Subject: **Bid No. 8691-J6 –Water Main Improvements–Chandler+May Street / DPW**

ADDENDUM NO. 3

Figure No. ADD-3 Lovell Street and Chandler Street Intersection
 Chandler Street Water Main Improvements and Large Diameter Valve Replacements
 Worcester, Massachusetts

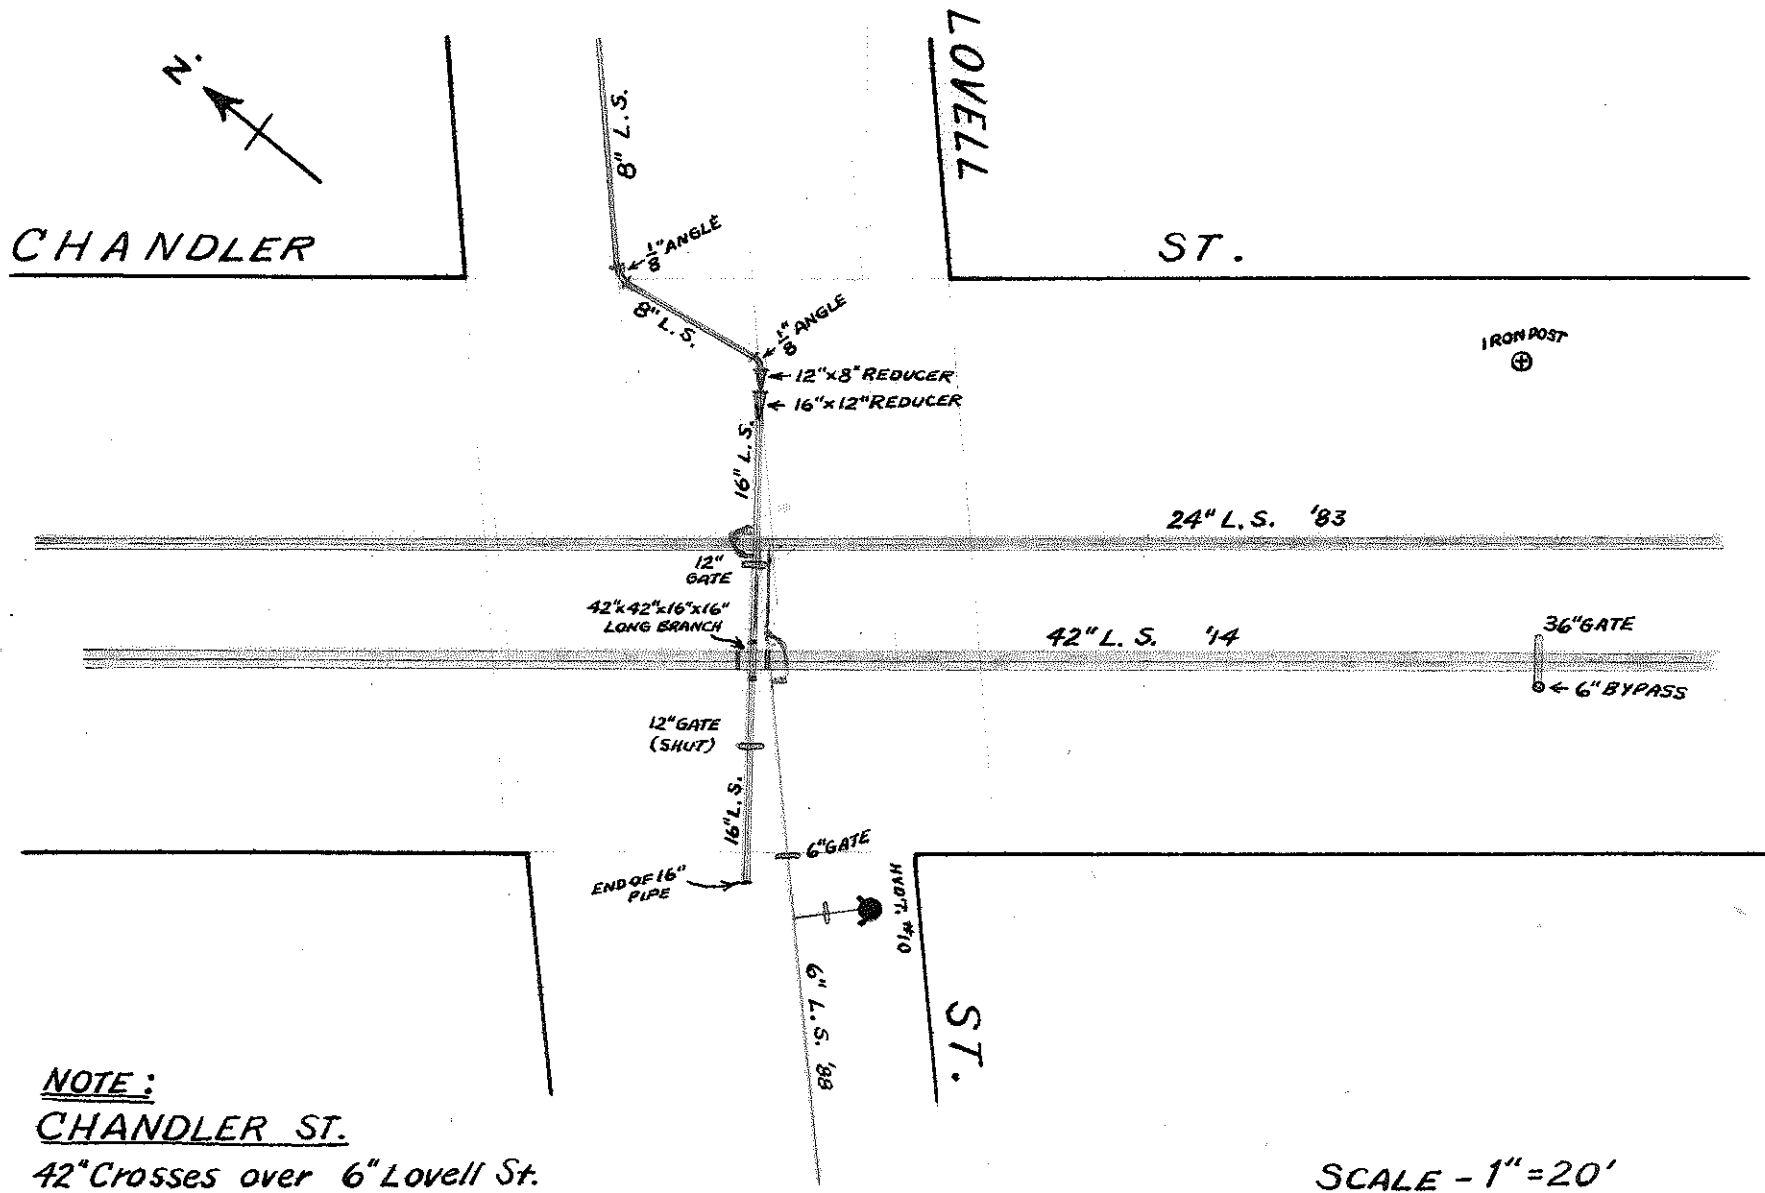
- Q2. On Figure 3E-P, it states that the contractor is to replace a 12-inch gate valve on the north side of the 42-inch existing cross with a 16-inch gate valve. Is the contractor replacing what is assumed to be a 42"x24" reducer and 24"x16" reducer as well, thusly eliminating the 16"x12" reducer? It states that the contractor is to install a new 16"x12" reducer south of the existing 42" cross. Is the contractor leaving the 42"x16" reducer.

- A2. Reference attached Figure No. ADD-3. The Chandler Street/Lovell Street intersection includes a 42-inch by 42-inch by 16-inch by 16-inch long branch cross at the connection between the Lovell Street 16-inch diameter water main and the Chandler Street 42-inch water main. The 6-inch diameter water main shown on Figure No. ADD-3 is now an 8-inch diameter water main. The Chandler Street 24-inch diameter water main does not connect to the Lovell Street 16-inch diameter water main. South of the existing 42-inch by 42-inch by 16-inch by 16-inch cross, a new 16x12-inch reducer shall be installed, the existing 12-inch valve replaced with a new 12-inch valve*

and new 12-inch diameter water main installed to connect to the existing 8-inch stub off the existing 8-inch diameter water main on Lovell Street. The existing 8-inch gate valve shall be replaced and a new 8-inch gate valve installed on the 8-inch diameter water main on Lovell Street. This is shown on Figure 3E-E and Figure 3E-P. North of the existing 42-inch by 42-inch by 16-inch by 16-inch cross, the existing 12-inch valve shall be replaced with a new 16-inch valve, and new 16-inch diameter water main shall be installed and connected to existing 16-inch diameter water main on the north side of the cross.
